GULF STATES UTILITIES COMPANY

March 29, 1984
RBG-17,456
File No. G9.5, G9.8.6.1

River Bend Station Unit 1
Docket No. 50-458

Enclosed for your review are Gulf States Utilities Company (GSU) responses to Request for Additional Information identified by the Nuclear Regulatory Commission's Power Systems Branch (PSB). This letter supplements information contained in docketed correspondence from J. E. Booker to H. R. Denton dated December 30, 1983, February 10, 1984, March 5, 1984, and March 7, 1984. Attachment 1 of this letter summarizes the Staffs request identified in a meeting between GSU and PSB dated February 15, 1984. These changes will be incorporated into the FSAR in a future amendment.

ENCLOSURE 2

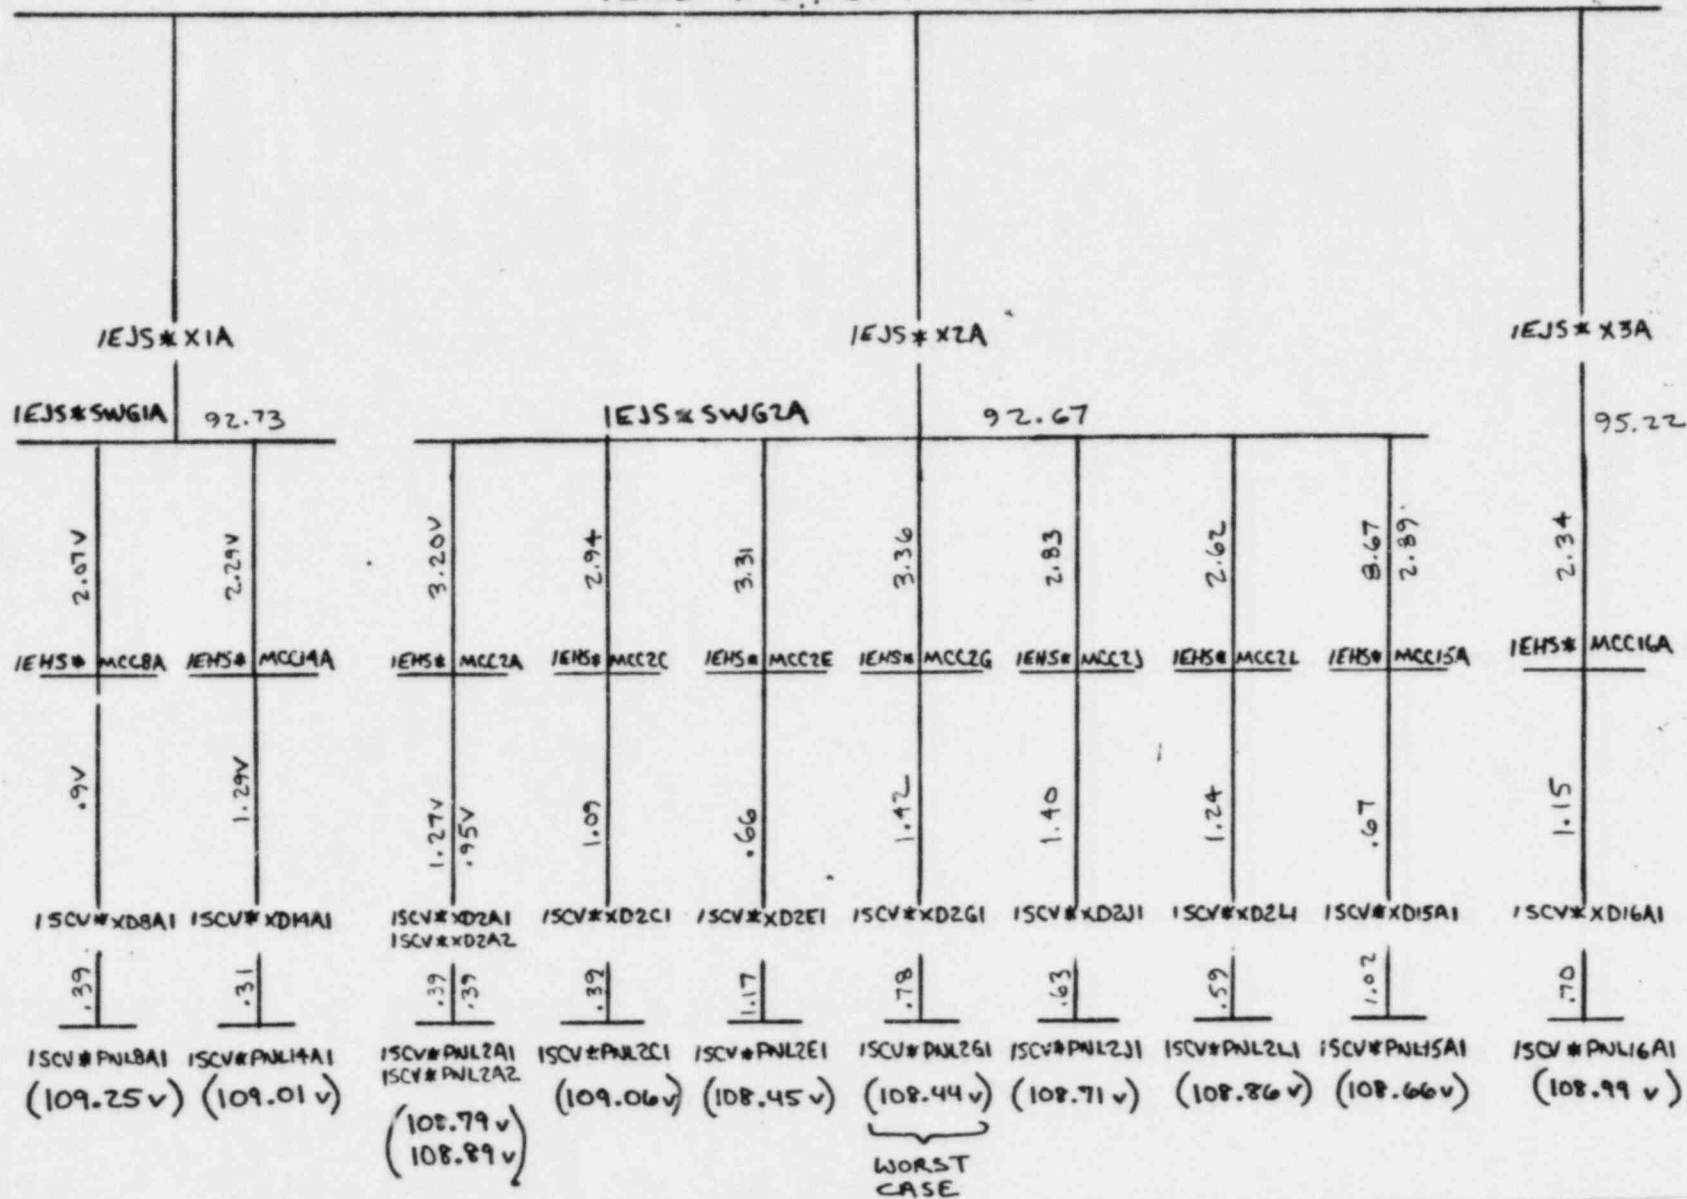
1. Expand your discussion to address under voltage protection for lower voltage level requirements (i.e. down to 120 volts).

With the GSU grid at 95% voltage, the worst case (fully loaded) voltage on the Class 1E 4.16 kV bus is 93.9%. This 93.9% voltage at the 4.16 kV level results in 92.67% voltage on the Class 1E 480V bus and 90.4% voltage at the Class 1E 120V panels. Final load study calculations will provide more accurate information for voltage profile calculations, and will result in final relay setpoints. Using these loading conditions, voltage on the Class 1E 120V will be calculated assuming 90% on the 4.16 kV bus. Should the voltage at the 120V bus be insufficient to furnish rated voltage to low

voltage Class 1F loads, the transformer trip setting will be revised or undervoltage relays will be added on the 120 volt buses. Additional one line sketches are provided in Enclosure 2.

FIGURE 8.3-6

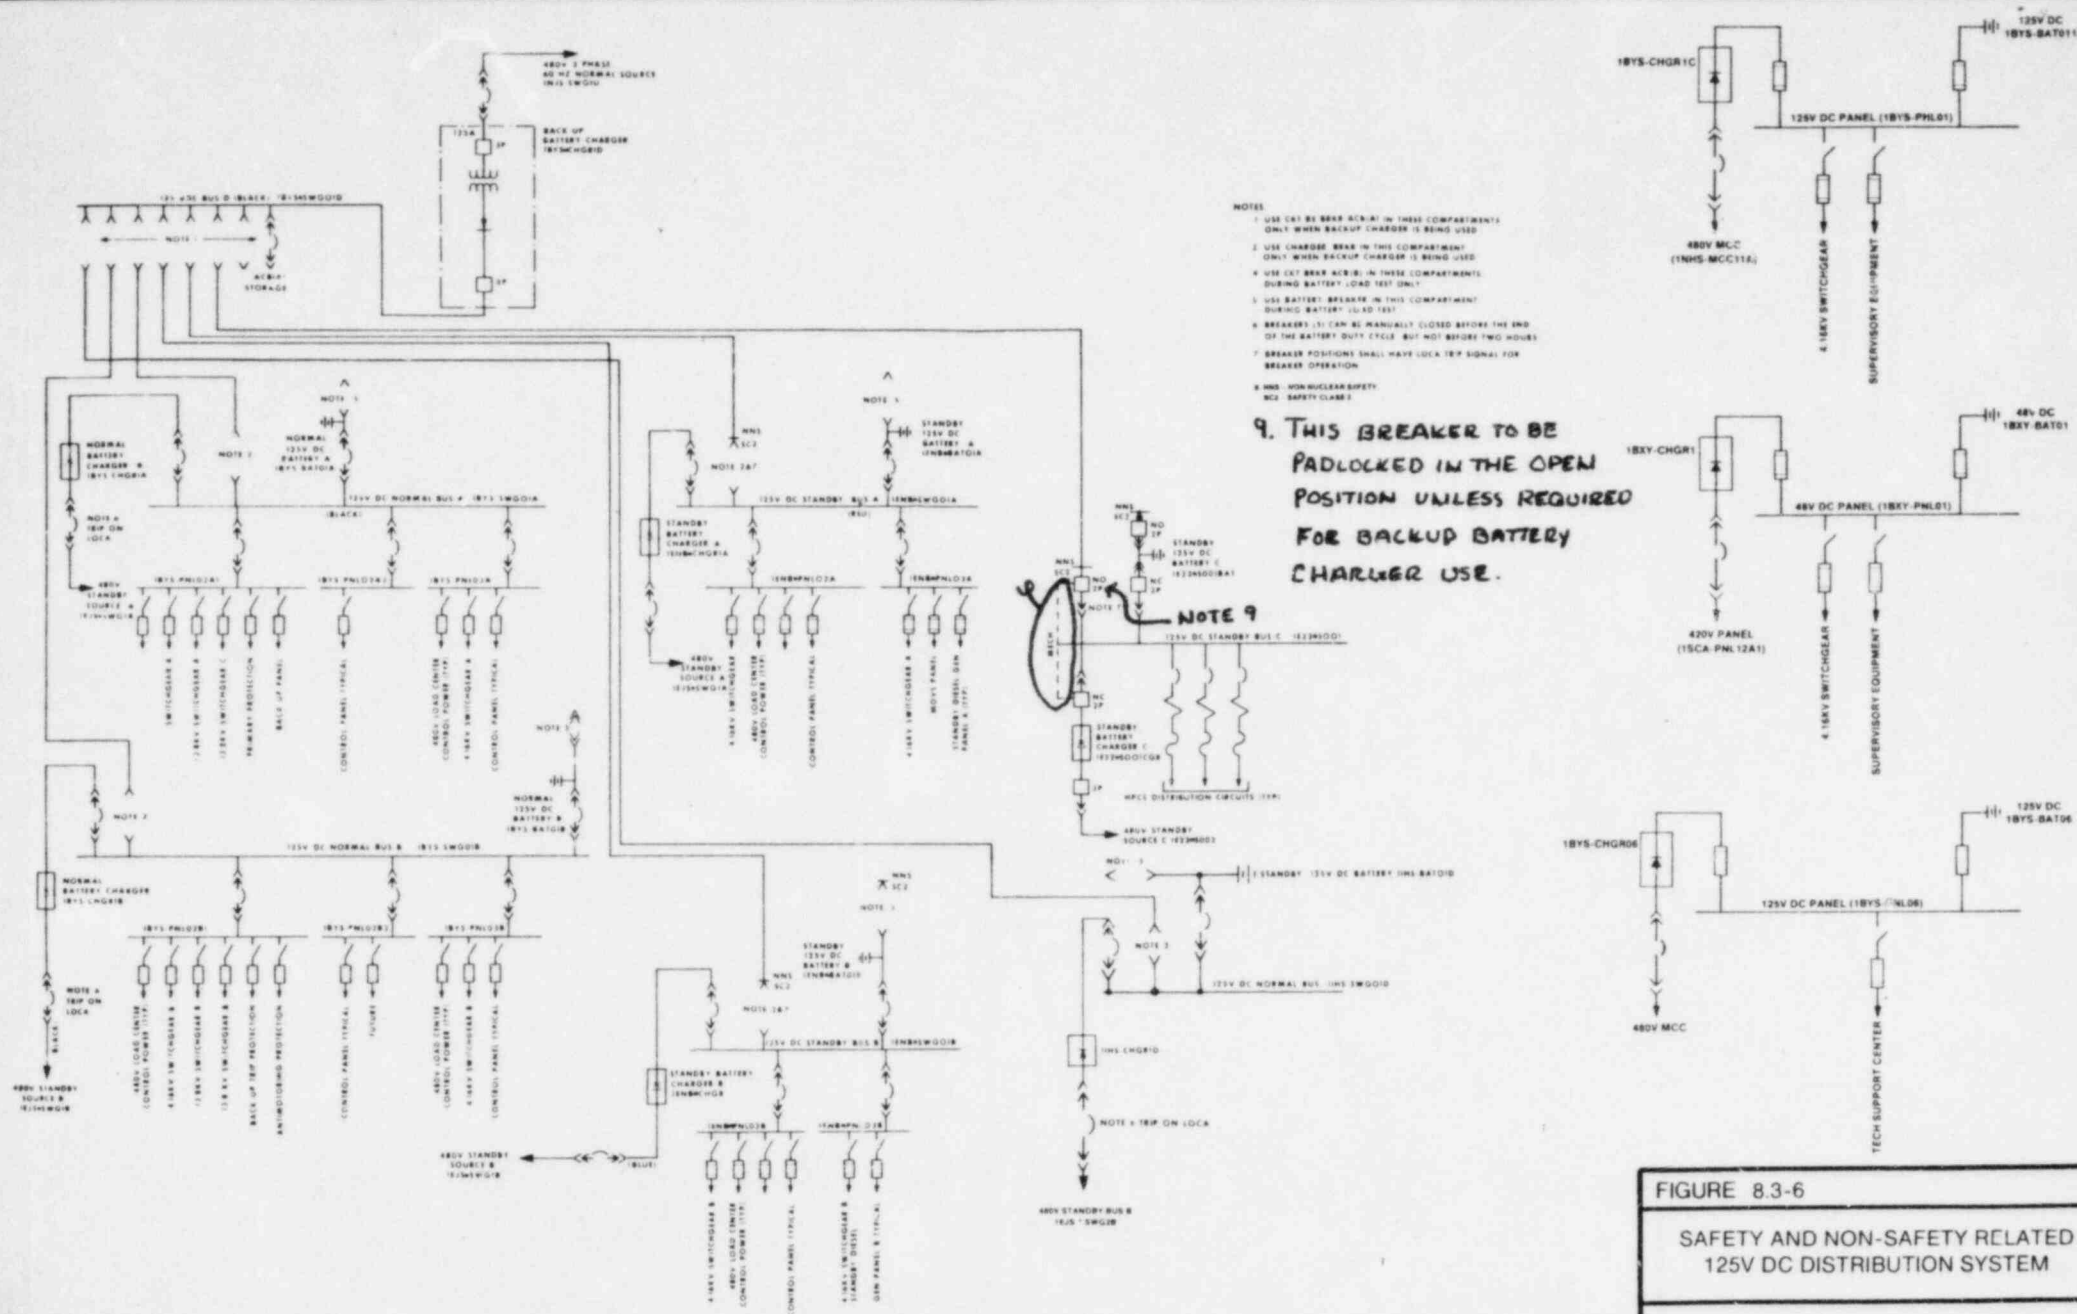
1. A backup battery charger interlock must be provided.

In addition to the response provided in the March 5, 1984 letter from J. E. Booker to H. R. Denton, revised FSAR figures are provided in Enclosure 3. In addition, pad locking the backup battery charger circuit breaker in the OPEN position will ensure electrical isolation between the Division III 125 VDC panel board and other electrical systems.
